SCHILLINGER COMMERCE PLACE SUBDIVISION

APPLICATION NUMBER 11 DATE April 4, 2013

REQUEST Subdivision

DETAIL SITE PLAN

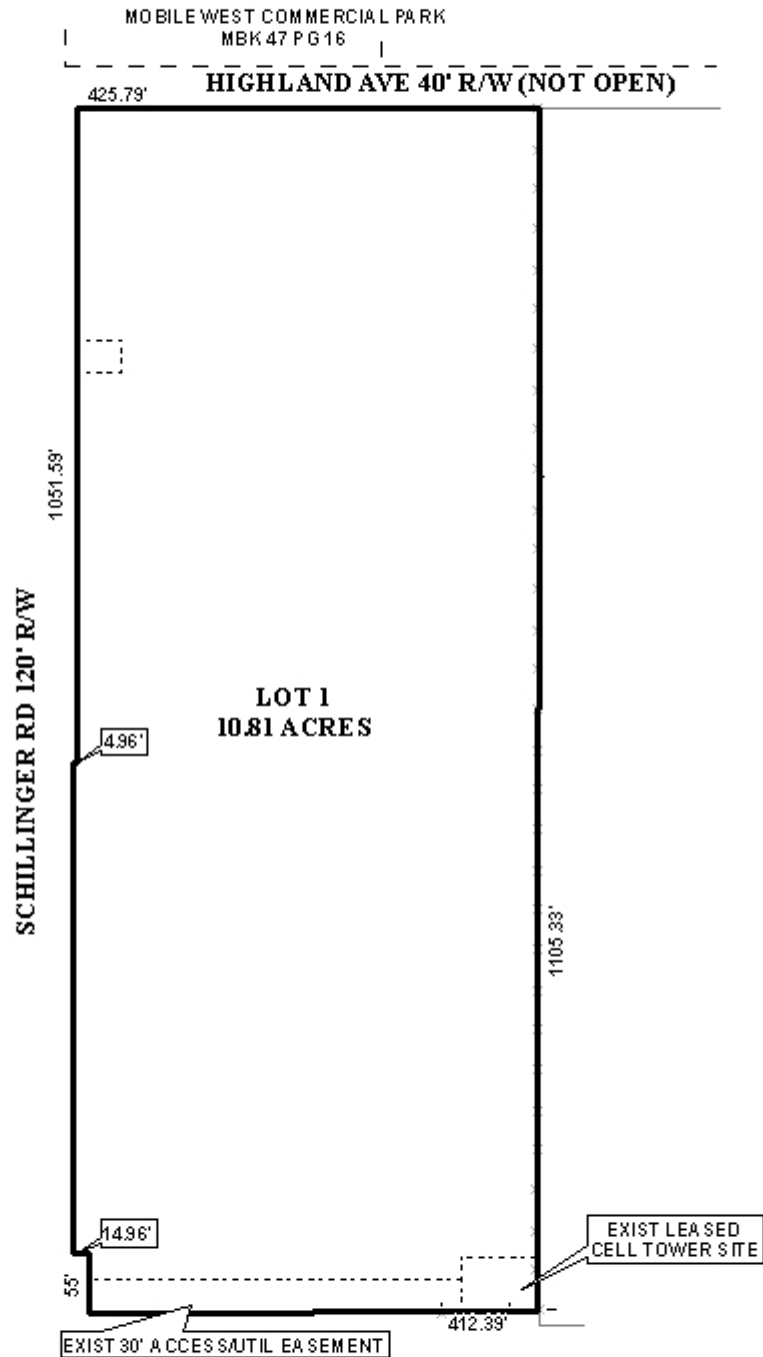
It should be noted that parcel data within the City GIS system incorrectly indicates the subject site as extending Northward across Highland Avenue to the South side of Mobile West Commercial Park. However, as that recorded subdivision plat clearly indicates Highland Avenue as a 40' right-of-way being located along the North side of the South boundary line of Section 18, Township 4 South, Range 2 West, that would place it along the North side of the North boundary line of Section 19, Township 4 South, Range 2 West, and along the North side of the North boundary of the subject site, as indicated on the plat.

Highland Avenue is a minor street requiring a 50' right-of-way with a current 40' right-of-way; therefore, dedication would be required to provide 25' from the centerline of Highland Avenue. The plat should be revised to provide a 25' radius curve dedication at the Southeast corner of Schillinger Road South and Highland Avenue. As a means of access management, a note should be required on the Final Plat stating that the site is limited to two curb cuts to Schillinger Road South, with the size, location and design to be approved by Traffic Engineering and conform to AASHTO standards. A note should also be placed on the Final Plat stating that access to Highland Avenue is denied.

The plat should be revised to indicate the 25' minimum building setback line as measured along Schillinger Road South from the current right-of-way, and as measured along Highland Avenue from any required dedication. At the Southeast corner of Schillinger Road South and Highland Avenue, the 25' minimum building setback line should be measured from the required radius curve dedication. As on the preliminary plat, the lot should be labeled on the Final Plat with its size in square feet and acres, after all required dedications, or a table should be furnished on the Final Plat providing the same information.

The plat indicates a drainage easement along Schillinger Road South within the Northern portion of the proposed lot, and a 30' access and utility easement along the Southern boundary of the proposed lot leading to a cellular tower within the Southeast corner. As such, a note should be required on the Final Plat stating that no structures are to be erected within any easement.

The site is located along the City-County border with properties to the rear being in the County with a mix of residential use and vacant land. Therefore, a note should be placed on the Final Plat stating that a buffer, in compliance with Section V.A.8. of the Subdivision Regulations must be provided where the site adjoins any residential use.

- 1) dedication to provide 25' from the centerline of Highland Avenue;
- 2) dedication of a 25' radius curve at the intersection of Schillinger Road South and Highland Avenue;
- 3) placement of a note on the Final Plat stating that the site is limited to two curb cuts to Schillinger Road South, with the size, location and design to be approved by Traffic Engineering and conform to AASHTO standards;
- 4) placement of a note on the Final Plat stating that access to Highland Avenue is denied;
- 5) revision of the plat to indicate the 25' minimum building setback line along Schillinger Road South as measured from the current right-of-way line;
- 6) revision of the plat to indicate the 25' minimum building setback line along Highland Avenue as measured from any required dedication;

- 7) revision of the plat to indicate the 25' minimum building setback line as measured from the dedicated radius curve at the Southeast corner of Schillinger Road South and Highland Avenue;

- 8) revision of the plat to indicate the lot size in square feet and acres as calculated after any required dedications, or the furnishing of a table on the Final Plat providing the same information;

- 9) placement of a note on the Final Plat stating that no structures are to be erected within any easement;
- 10) placement of a note on the Final Plat stating that a buffer, in compliance with Section V.A.8. of the Subdivision Regulations must be provided where the site adjoins any residential use;
